CALL NO. 100 CONTRACT ID NO. 161054 ADDENDUM # 1

Subject: Pike County, NHPP 0806 (046) Letting October 28, 2016

(1)Revised - Plans - S02

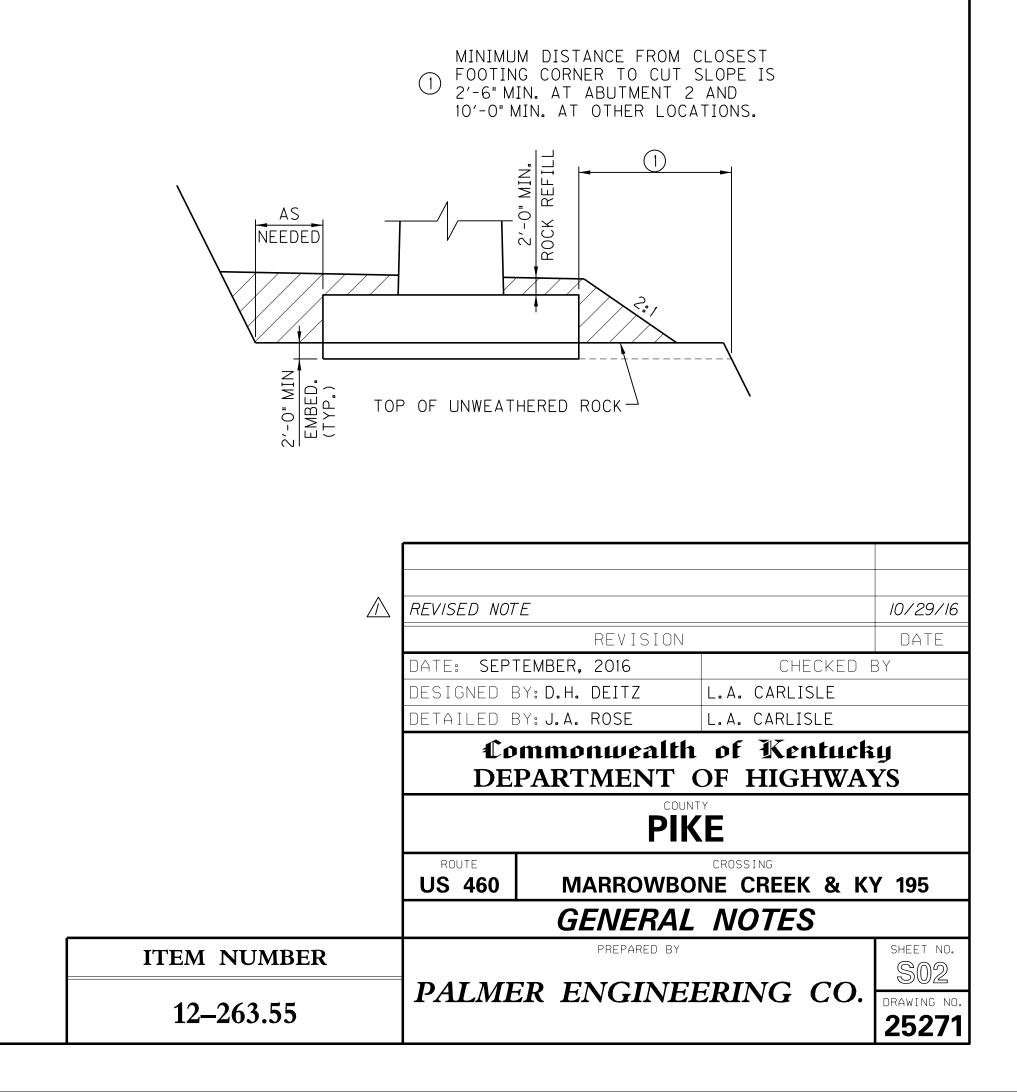
As shown in the detail below, a minimum of 10'-0" of sound rock bench shall be left between the edges of all footings and a lower cut slope with the exception of Abutment 2 where a minimum of 2'-6" is required.
